CITY OF FORT COLLINS

ADDENDUM No. 1  
BID #5767  
LEMAY AVENUE WIDENING PROJECT

Description of Bid #5767 Lemay Avenue Widening Project

# ACO DRAIN® III

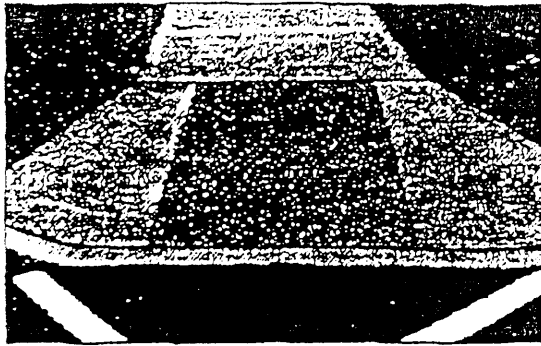
- II. There has been a change regarding the drain in the underpass. The plans show the drain being 0.50 feet deep and the change is to make it only **2.55" deep**. There is an attachment labeled "**Attachment #1**" that shows the specifications for this drain.
- III. There was an error on our bid schedule: there is a typo that needs to be corrected

**Invert depth:** Channels w/frame 3.75"/95mm (H 080) and 4.5"/115mm (H 100) wo/frame, 2.55"/65mm and 3.34"/85mm.

BLIND PATH ADA  
FLEXIBLE MAT STAMPING TOOL

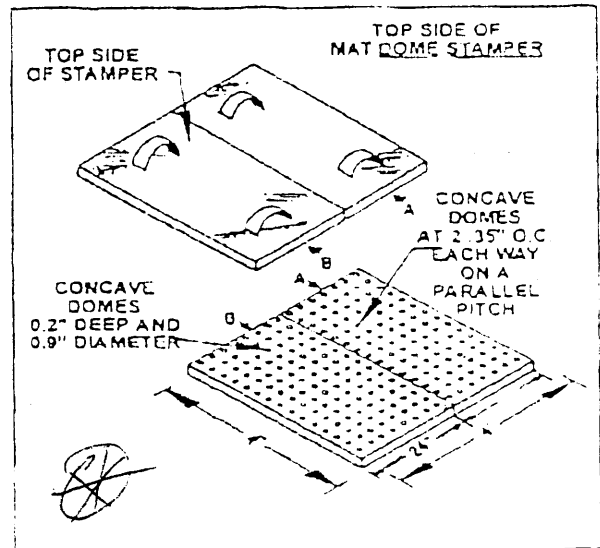
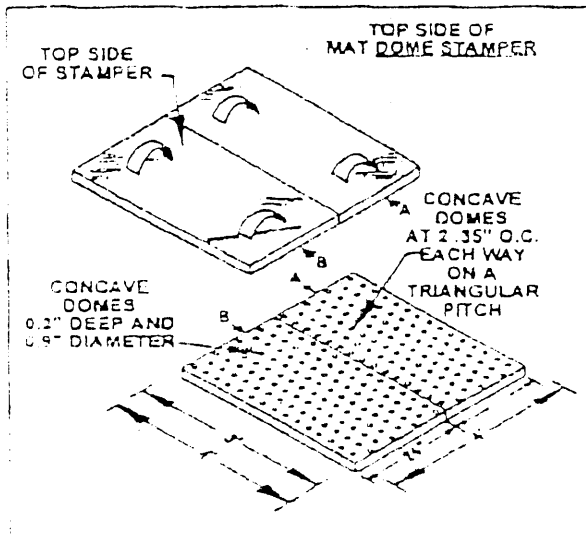
- XII. The details on the plans show the truncated domes being constructed of brick pavers. The technical specifications call for a flexible matt stamping tool to create the truncated domes. We want the domes to be constructed with the stamp. There is an attachment labeled "**Attachment 2a & Attachment 2b**" that gives an example of what we want.
